# **Safety Evaluation Report**

Related to the License Renewal of the Millstone  
Power Station, Units 2 and 3

Docket Nos. 50-336 and 50-423

**Dominion Nuclear Connecticut, Inc.**

**Figure A: Trend Line Relationship with Horizontal Tendons**

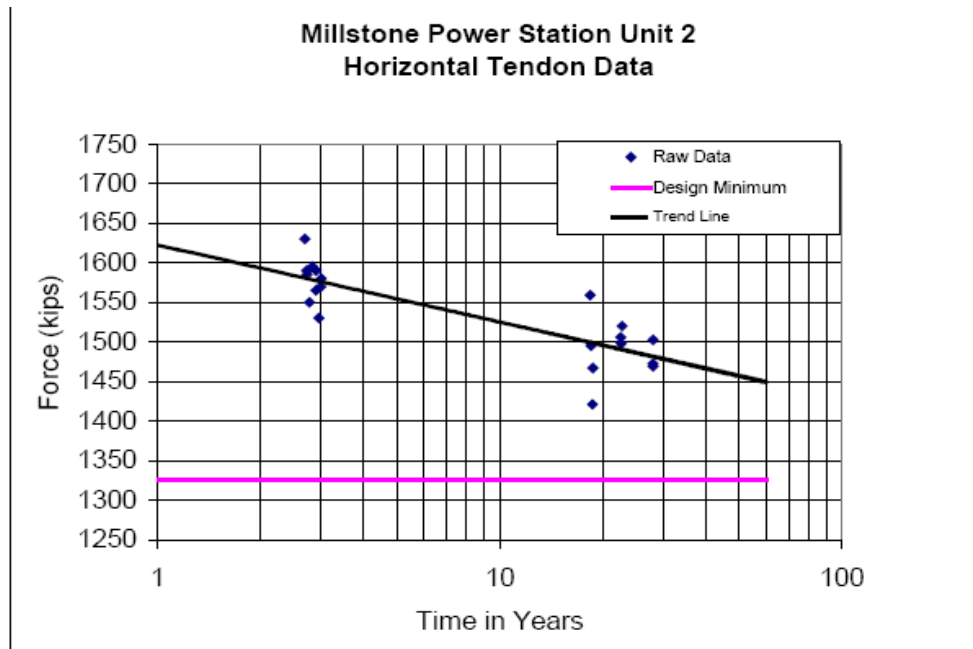
In RAI 4.5-4, the staff noted that the number of tendons sampled (i.e., 4 percent and 2 percent of the population of the group of tendons) during each tendon inspection is small, and that the sample size is not amenable to statistical analysis for establishing confidence levels (column 3 of Tables 4.5-1, 4.5-2, and 4.5-3) during each inspection based on the measured results. The staff also pointed out that, as the sample size of each tendon inspection is small, Attachment 3 of NRC Information Notice 99-10, Revision 1, recommended regression analysis of the measured tendon forces without averaging or any statistical calculation. The applicant was requested to provide more information about the values in column three of the identified tables and an explanation of measured tendon force values used in the regression analysis.

In its January 11, 2005 response, the applicant removed the tables provided in the LRA, and substituted new tables showing measured prestressing forces during tendon inspections for each group of tendons. In response to the staff's follow-up question as to why 3-, 5-, and 10-year data are missing from the tables, the applicant stated that as these tendons went through repeated tensioning and detensioning, the data were not reliable. The measurements taken during the 1-, 15-, 20-, and 25-year inspections were used for developing the trend lines. In Figures 1, 2, and 3 of the revised response (dated January, 11 2005), the applicant provided the trend lines and the measured tendon force data. Figure A, showing the trend line related to horizontal tendons, is reproduced below:
